**Subject: Important information regarding the safety of Monnal T60 ventilators (Ref R2218602)**

This corrective action involves updating all devices in the Monnal T60 range placed on the market, by deploying the software versions listed below, as well as providing a new associated user manual (UM):

- Monnal T60 range: software version V2.8.x
- Monnal T60 Advanced range: software version V1.2.x

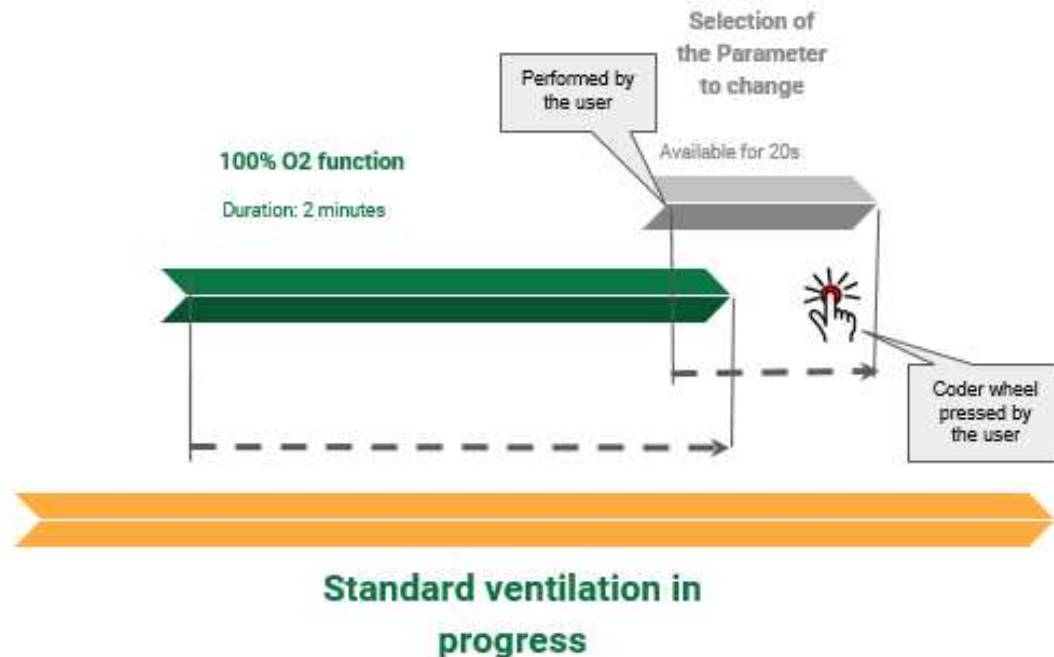
### ***Situation 1: Possibility of having an Fio2 setpoint applied that is different to the setpoint displayed after using the 100% O2 function.***

Description of the problem: If the user wants to change the FIO2 setpoint a few seconds before the end of the two-minute period of the 100% O2 function, and this setpoint was confirmed just after the end of the 100% O2 function (see graph below), this can cause a conflict between the setpoint applied and its display.

Air Liquide Medical has introduced a software correction that will prevent any "Awaiting confirmation" parameter from being maintained after the 100% O2 function two-minute period.
